UNITS:mm	SCALE: 2/1	SHEET: 1 OF 1	MODEL NO.: DC5821
MATERIAL: PORON(HH-48)	TREATMENT:		
DSGD by	Ferris Tsai	28-Aug-18	PART NAME: LAMP SENSOR HOLDER
CHK by			
APVD by			PART NO.: 3MD333TH02A REV. A
APVD NO.:	3D FILE NAME: 58_SENSOR_BD_PAD-2		DIVA Laboratories, Ltd.

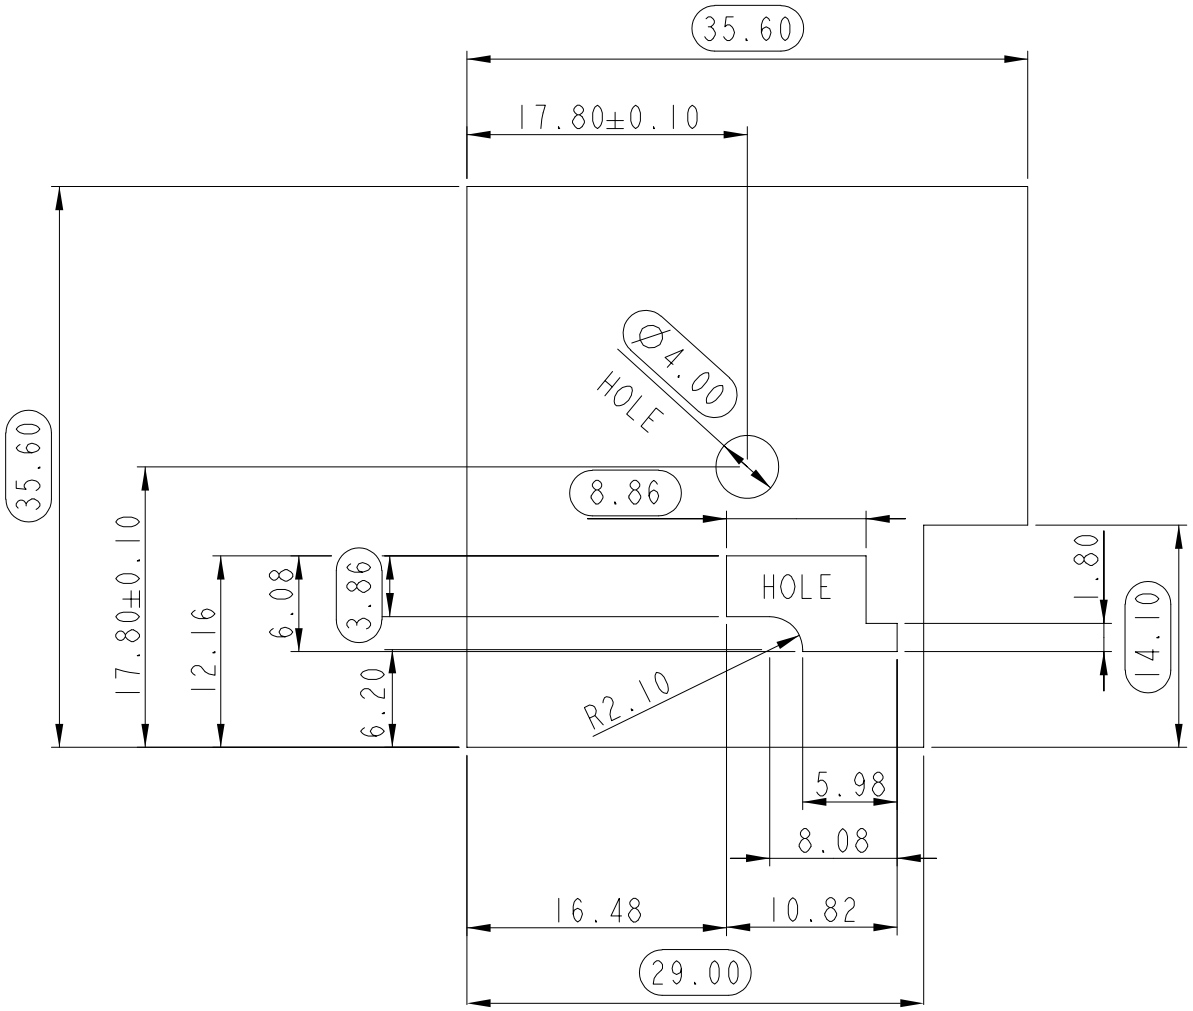
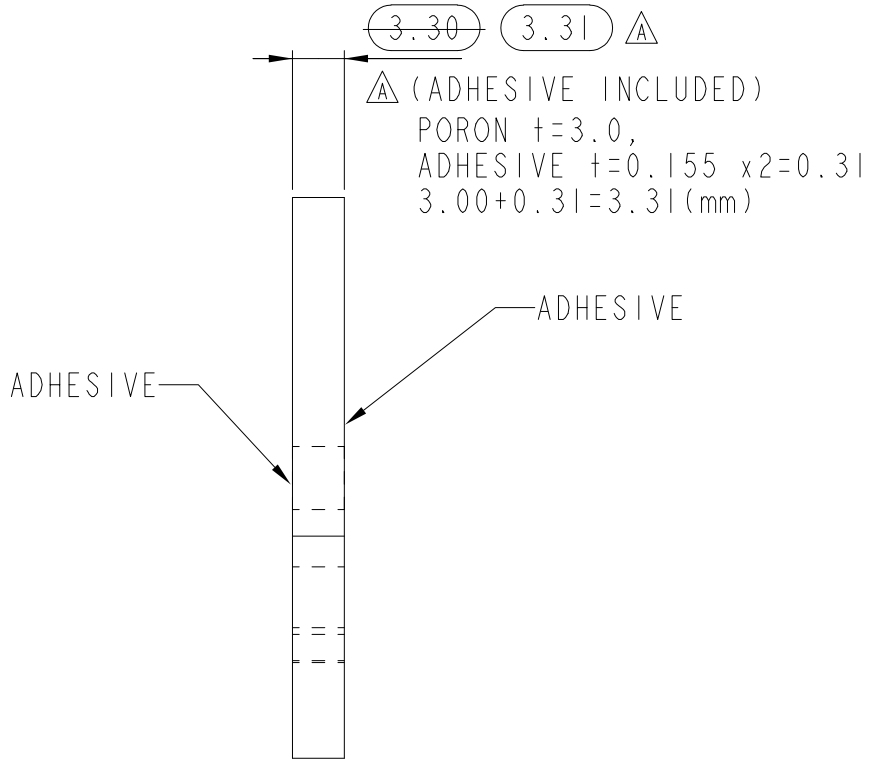
REV.	DAIE	DESCRIPIION	BY	APVD
A	2025.09.11	ADHESIVE FROM SONY G9000 CHANGE TO Dexerials T911, PART NUMBER FROM 3MD333TH020 CHANGE TO 3MD333TH02A.	Ferris Tsai

NOTE:
1. MATERIAL: PORON(HH-48), t=3.0mm
2. COLOR: BLACK
3. ADHESIVE: ~~SONY G9000, t=0.15mm(DOUBLE SIDE)~~
   A Dexerials T911, t=0.155mm(DOUBLE SIDE)
4. IQC INSPECTION DOCUMENT NO: QWI-024
